**Addendum No. 2 to ITB 2018-02
MEDART LIFT STATION BYPASS
Issued February 15, 2018**

ADDENDUM NO. 2

DATE: February 15, 2018
TO: ALL PLAN HOLDERS
FROM: DEWBERRY | PREBLE-RISH
324 MARINA DRIVE
PORT ST. JOE, FL 32456
850.227.7200 850.227.7215 FAX
CC: DAVID EDWARDS, COUNTY ADMINISTRATOR, WAKULLA COUNTY
PHILIP JONES, PROJECT MANAGER, PRI
PROJECT NAME: MEDART LIFT STATION BYPASS
PROJECT NO.: 50097941

DETAIL THRUST RESTRAINTS

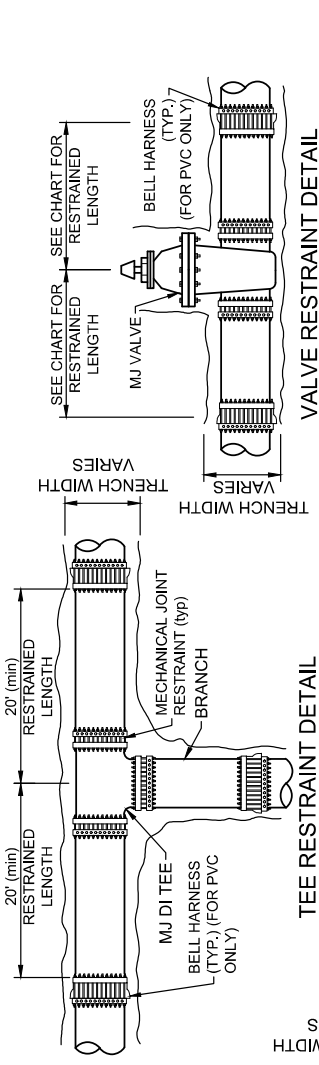
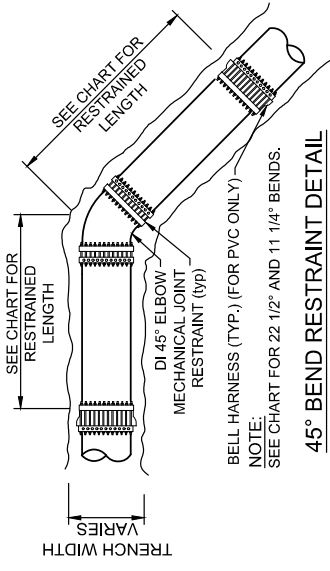
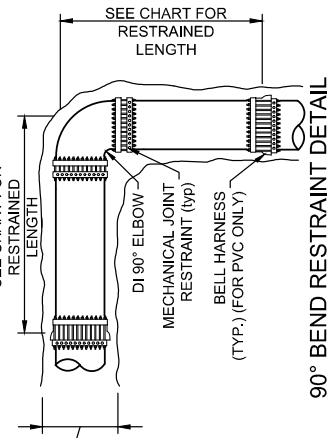
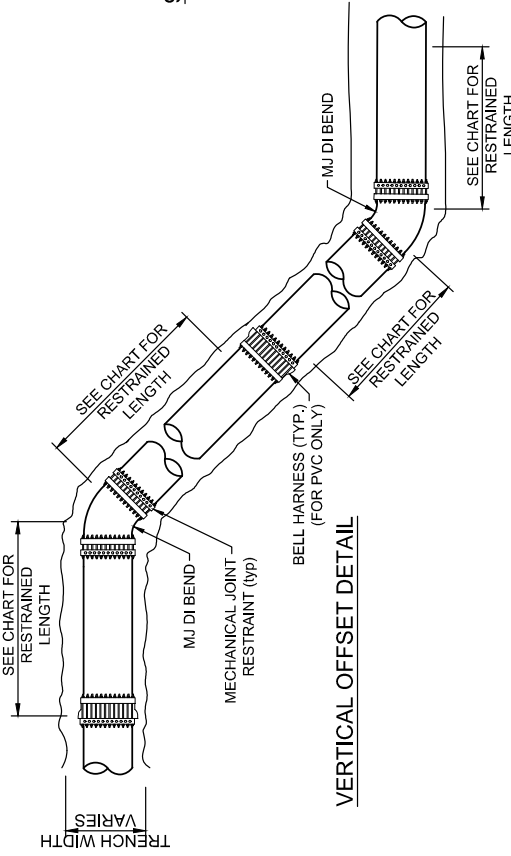
- Sheet D2: DIP THRUST RESTRAINTS and PVC THRUST RESTRAINTS details shall be replaced by THRUST RESTRAINTS detail in Attachment C.

1. RESTRAIN TO NEXT FULL JOINT BEYOND GIVEN LENGTH.
2. RESTRAIN 11.25' BENDS 50% OF LENGTH FOR 22.5° BENDS.
3. ALL VALVES AND FITTINGS SHALL BE RESTRAINED TO THE CONNECTING SECTIONS OF PIPE.
4. ALL VALVES MUST BE PROPERLY ANCHORED OR RESTRAINED TO RESIST A 150 PSI TEST PRESSURE IN EITHER DIRECTION.
5. PIPE SIZES ARE GIVEN IN INCHES.
6. PIPE LENGTHS ARE GIVEN IN FEET.
7. LENGTHS SHOWN ARE FOR A TEST PRESSURE OF 150 PSI.
8. RESTRAIN LENGTHS ARE TO BE USED FOR WATER.
9. THE RESTRAINED LENGTHS SHOWN IN THESE TABLES ARE BASED ON THE USE OF LIGHTLY COMPACTED CLEAN SAND WITH AT LEAST A 95% COARSE PARTICLE CONTENT. ACTUAL SOIL CONDITIONS MUST BE DETERMINED BY THE ENGINEER OF RECORD AND THE RESTRAINED LENGTHS MODIFIED ACCORDINGLY. SAFETY FACTOR OF 1.5:1 TO BE CALCULATED WITH A "SM" SOIL TYPE AND TRENCH TYPE "3".
